Access Compliance Report

Public Rights-of-Way

Intersection ID: 20860	Main Street: CROWNPOINT_EXECUTIVE_DR	Cross Street: KREFELD_DR	Location: NE
ADA ID: 76DEF566A98C	Ramp Type: PerpDiag	Initial Pass/Fail: Fail	Overall Compliance: No
		Severity Score: 12.5

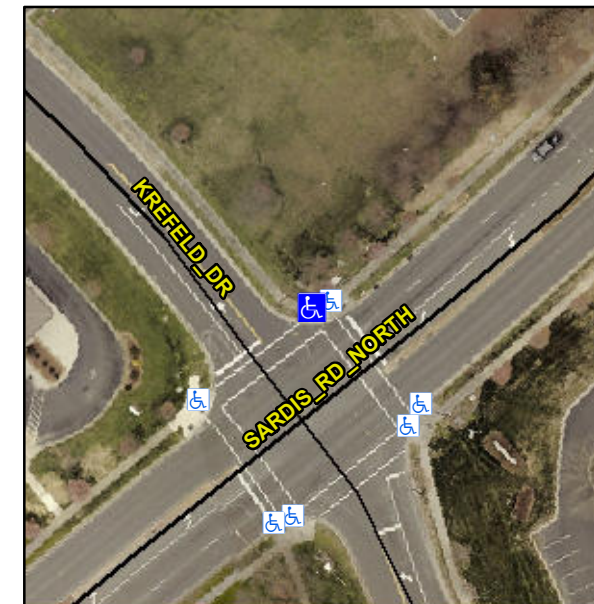
Not Found, R304.5.3

Compliance	Description	Data	Compliance	Description	Data
N/A	Ramp Length (in)	53.0	Yes	Ramp Slope (%)	6.3
Yes	Ramp Width (in)	48.0	No	Ramp XSlope (%)	5.8
N/A	Flare Type LT	N/A	N/A	Flare Type RT	N/A
N/A	Flare Slope LT (%)	N/A	N/A	Flare Slope RT (%)	N/A
N/A	Flare Traversable LT?	N/A	N/A	Flare Traversable RT?	N/A
N/A	Landing Length (in)	N/A	N/A	DWS Provided?	N/A
N/A	Landing Width (in)	N/A	N/A	DWS Contrast?	N/A
N/A	Landing Slope (%)	N/A	N/A	DWS Length (in)	N/A
N/A	Landing X Slope (%)	N/A	N/A	DWS Full Width?	N/A
N/A	Landing Curb? (Y/N)	N/A	N/A	DWS Offset (in)	N/A
N/A	Shared Landing?	N/A			
N/A	Gutter Ponding?	N/A	N/A	Gutter Slope (%)	N/A
N/A	Gutter Lip Ht (in)	N/A	N/A	Gutter X Slope (%)	N/A
N/A	Painted X Walk1?	Yes	N/A	Painted X Walk2?	Yes
	X Walk 1 Direction	To SW		X Walk 2 Direction	To SE
N/A	X Walk 1 Width (in)	110.0	N/A	X Walk 2 Width (in)	111.0
	X Walk 1 Slope (%)	2.8		X Walk 2 Slope (%)	5.2
	X Walk 1 X Slope (%)	2.8		X Walk 2 X Slope (%)	3.9

Remove & Replace Curb Ramp With Two New Directional Ramps or Equivalent. Restripe Crosswalk.
